<b>DOCKETED</b>	
<b>Docket Number:</b>	24-OPT-02
<b>Project Title:</b>	Compass Energy Storage Project
<b>TN #:</b>	265735
<b>Document Title:</b>	Roger Butow Comments - Alarming Earthquake Factors
<b>Description:</b>	N/A
<b>Filer:</b>	System
<b>Organization:</b>	Roger Butow
<b>Submitter Role:</b>	Public
<b>Submission Date:</b>	8/21/2025 11:07:57 AM
<b>Docketed Date:</b>	8/21/2025

## **Alarming Earthquake Factors**

## **BESS Facility In CSJC: Imminent Earthquake Predictable?**

### **CGS Survey Mapped Liquefaction Vulnerable Watersheds**

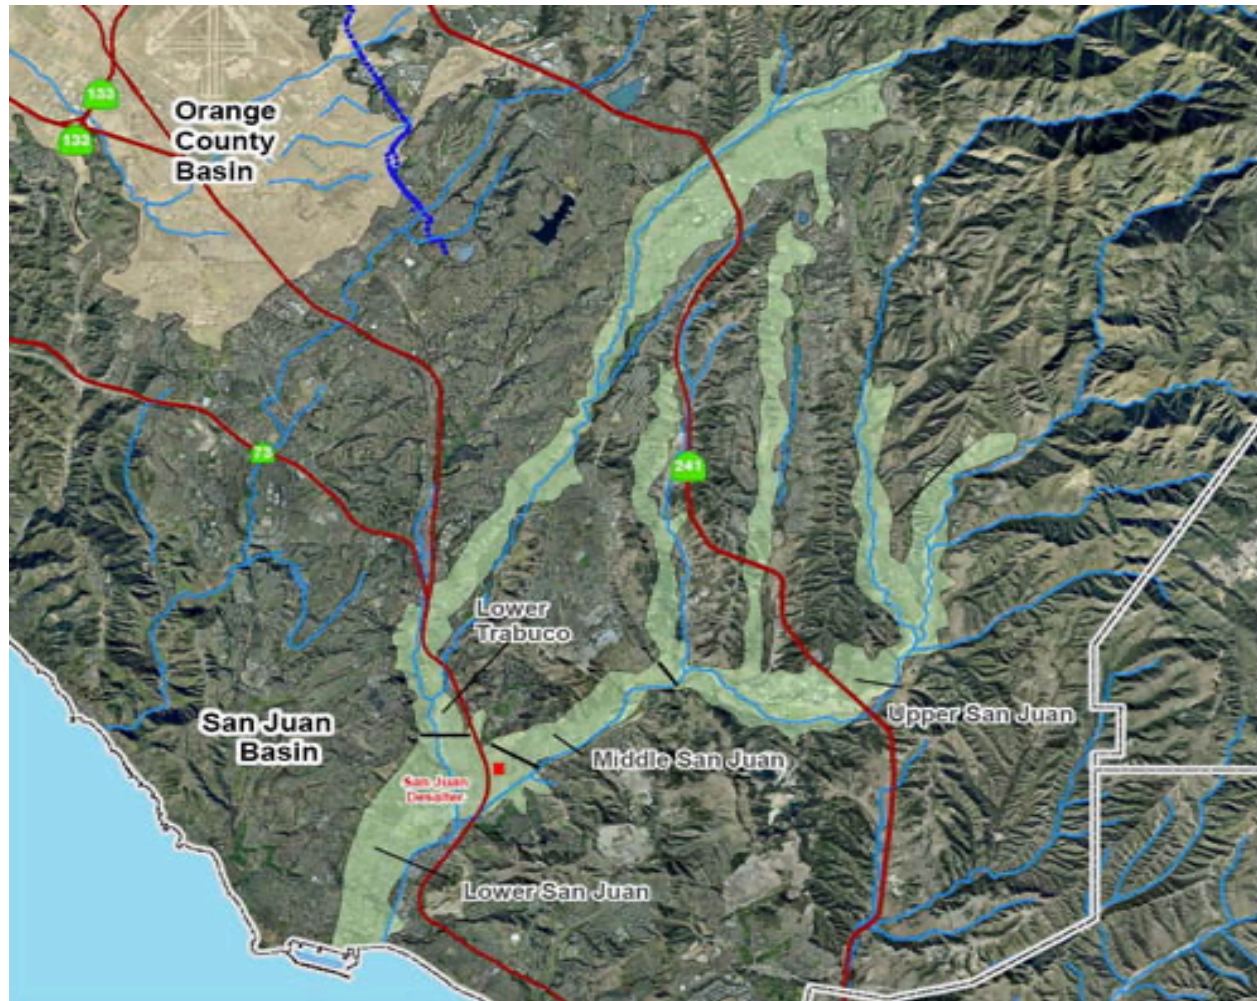
It would not be unreasonable, in fact quite logical, to inject for advanced, in depth analyses of potentially significant impacts demanding both dialogue and mitigation to include a swath which brings a perpendicular radius of 2-3 miles from the SJHBTF mapped center line.

Logic and common sense should encourage the Commission to consider it reasonable to prohibit any SOC BESS site facility (once

the SJHBTF bends, begins it's southerly direction towards Dan Point): Westward to Crown Vally Parkway, at minimum Eastward to (and including) the I-5 Freeway.

### SAN JUAN CREEK WATERSHED

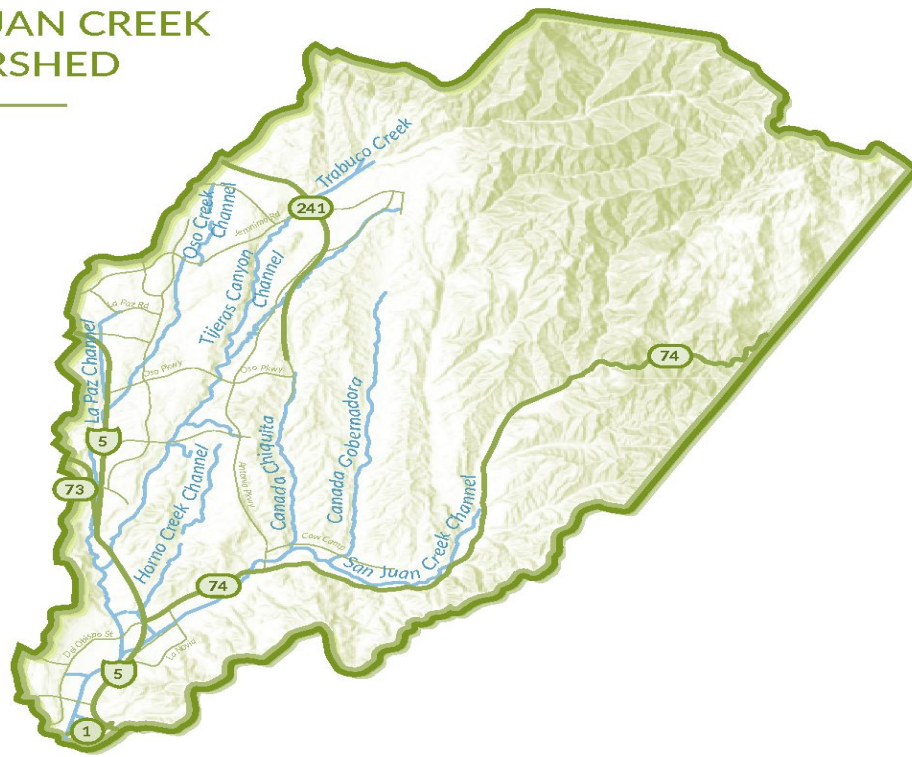
**Above:** Contributing major drainages to the mainstem of San Juan Creek are Oso, Trabuco, Tijeras, Horno, Chiquita, Gobernadora and Bell Canyon.
